Customer Service Bulletin Commercial Business Group

Multi Pro[®] 1200 and 1250

Subject: The Bracket for the Spray Gun may not fit-up to the front tank strap.

Figure 2

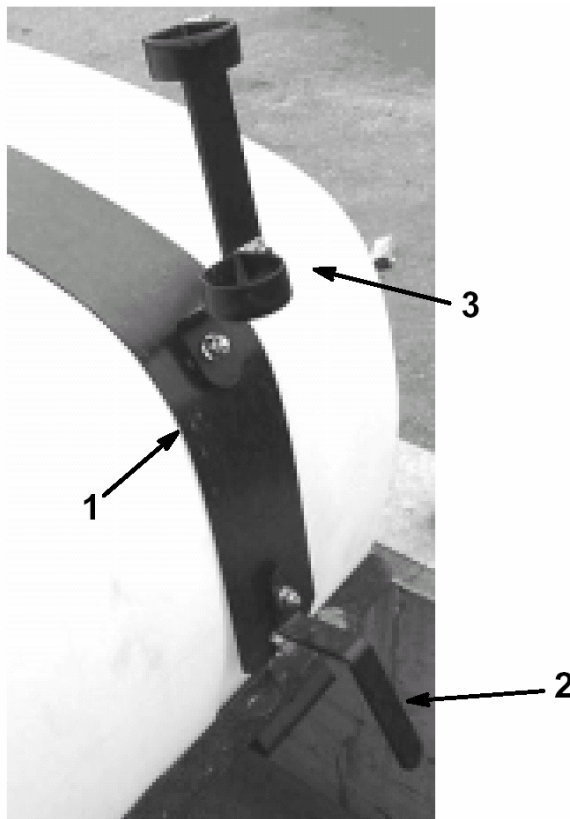
Early units produced in 2004 may not have a square hole in the front Tank Strap (106-5063-03) which is necessary to mount the Spray Gun Bracket from the Spray Gun Kit (41133). The square hole is only necessary when mounting the Spray Gun Kit.

Installing a Spray Gun Kit (41133) to one of the units listed will require the front Tank Strap (106-5063-03) be replaced. The part has been changed to include the necessary holes. Refer to the figure below for Hanger and Tank Strap orientation. Contact your Toro distributor should you encounter this situation and are going to mount the Spray Gun Bracket.
